CITY OF ALBUQUERQUE

Re: CNM Hazeldine Sidewalk Culvert Plan, 725 University Blvd (culvert on Hazeldine St.)

Engineer's Stamp dated 10-7-10 and 10-26-10 (K15/D076)

Based upon the information provided in your submittal received 10-26-10, the above referenced plan is approved for SO 19 Permit.

HAZELDINE ASPHALT OVERLAY PLAN

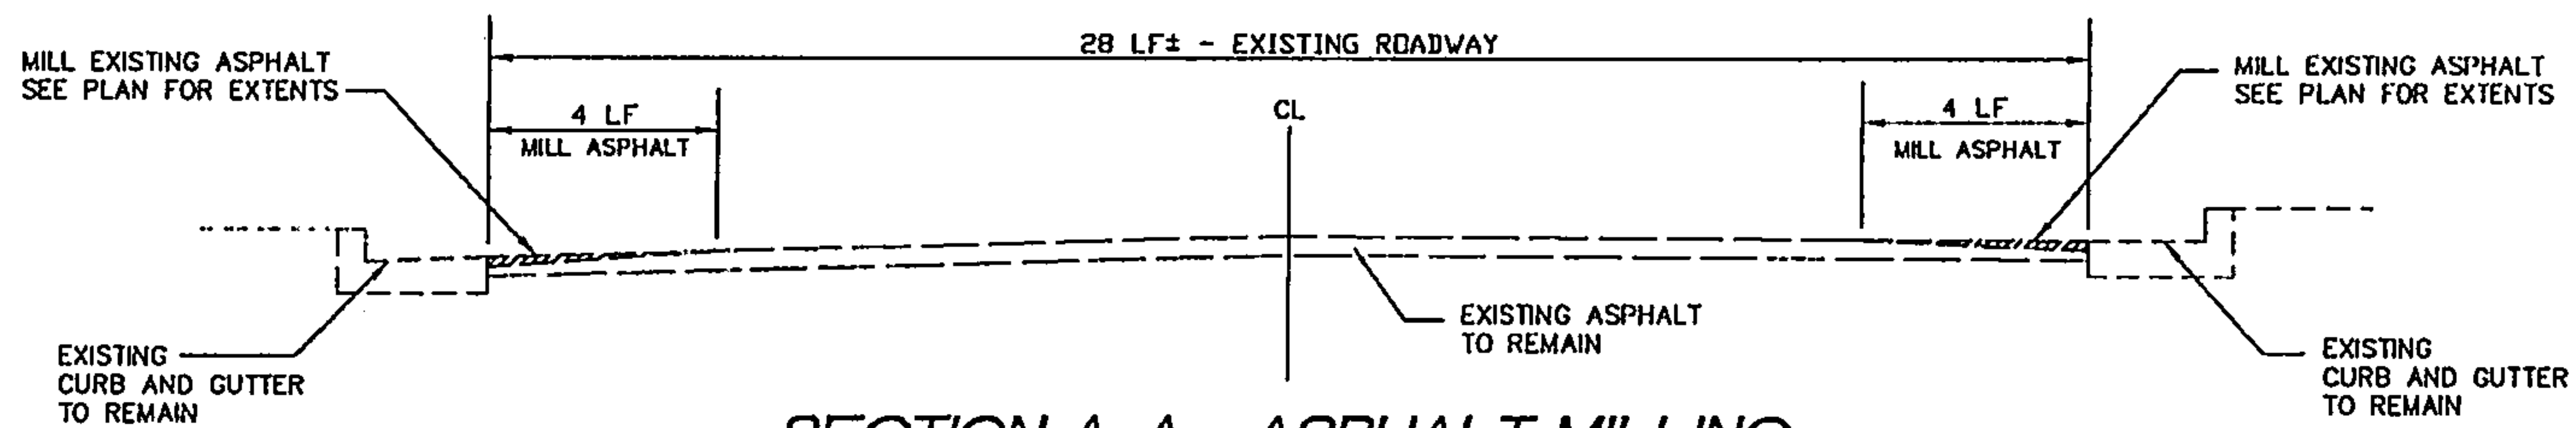
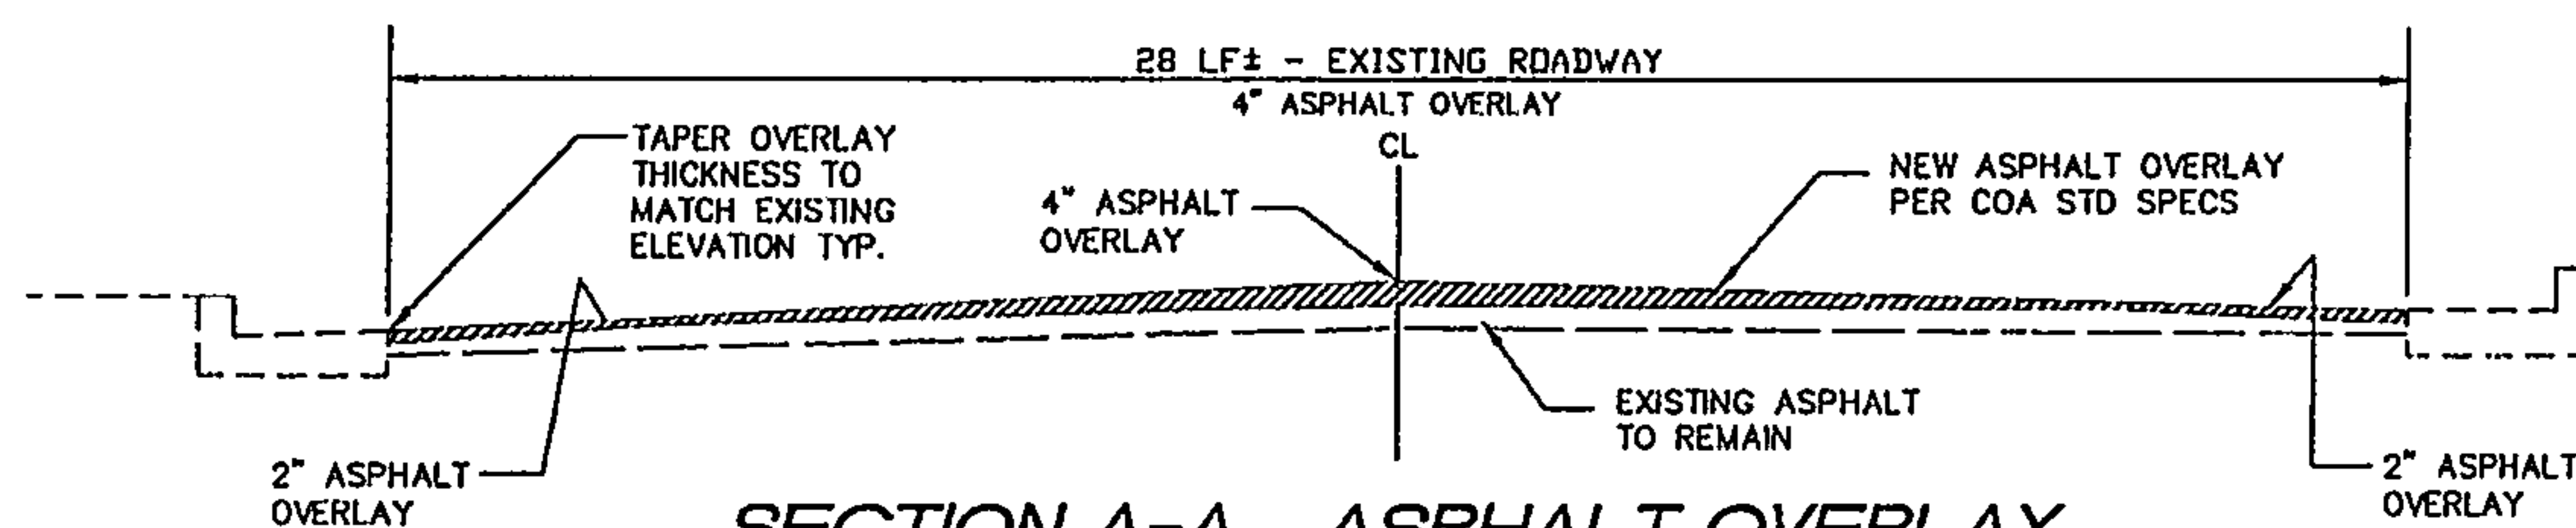
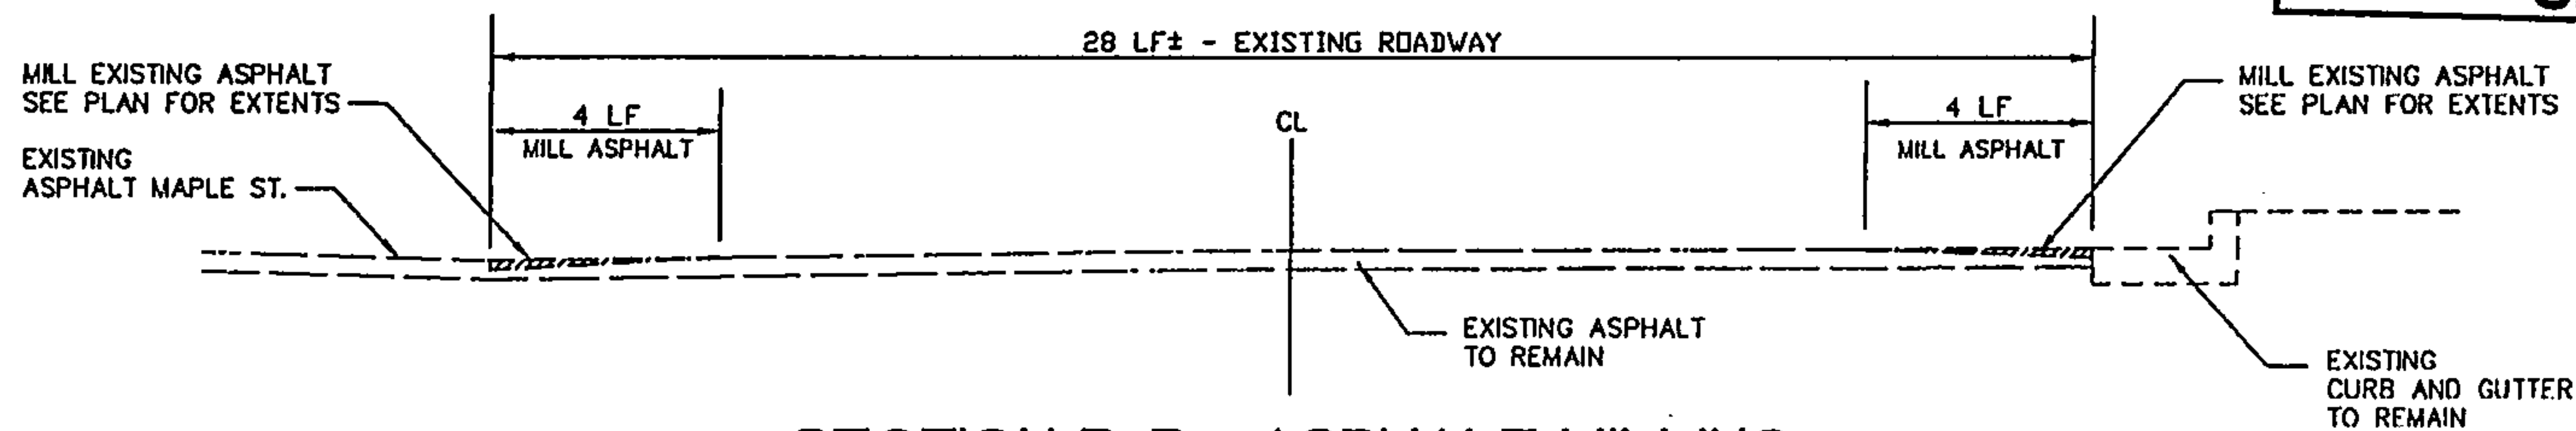
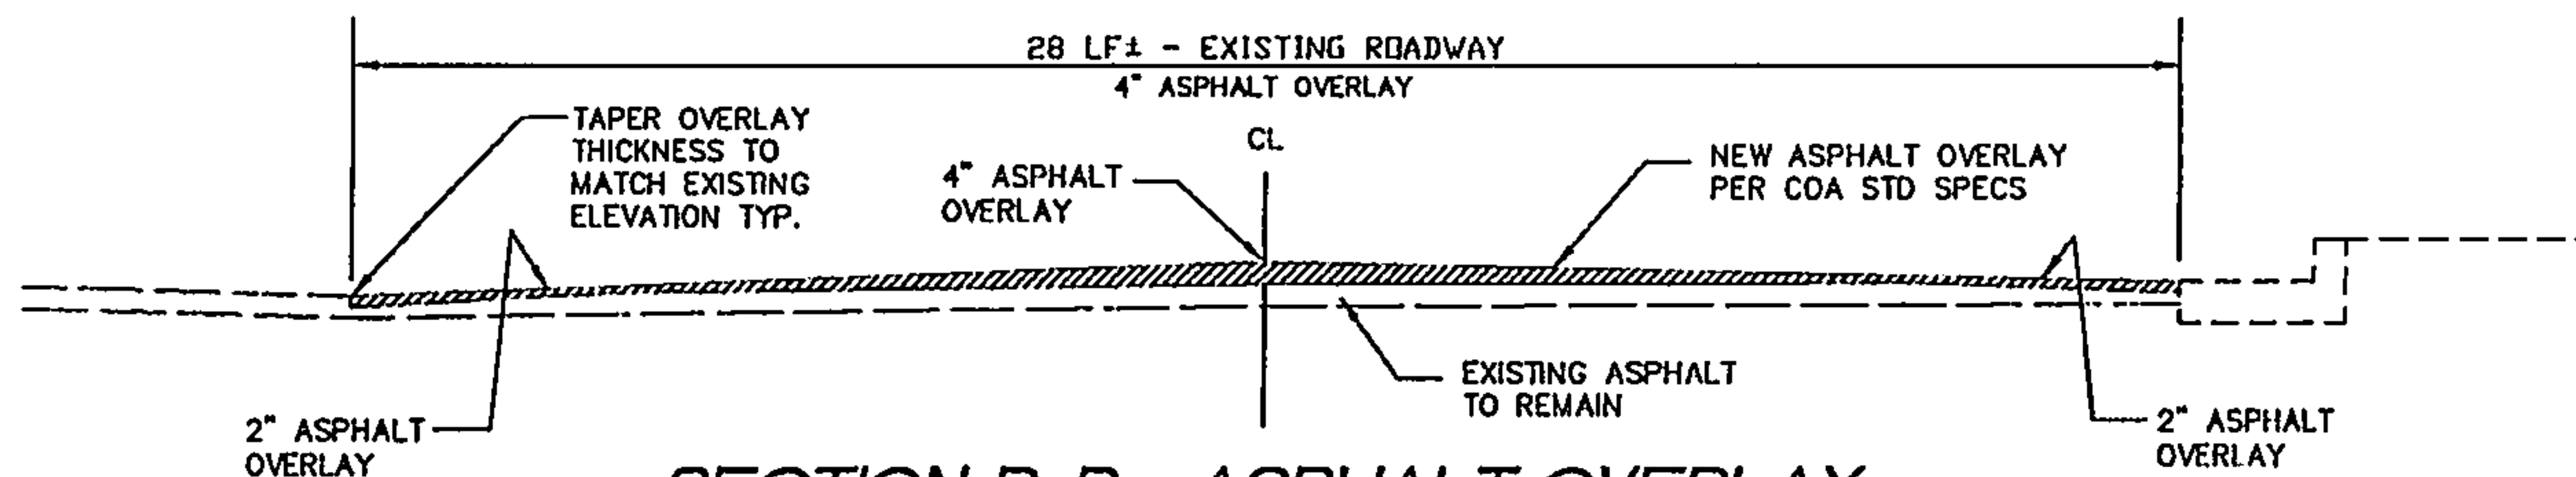
1. Show the property line. Are you planning on staying in the ROW?
2. Should you have a slope specified on the asphalt overlay sections? How do you know 4" will work?
3. Specify the type of asphalt and you'll probably need 2 lifts where it is 4" thick.
4. Provide the depth of the sidewalk culvert in Section A-A on DWG 2236 (Modified).
5. There should be a PE stamp on this.
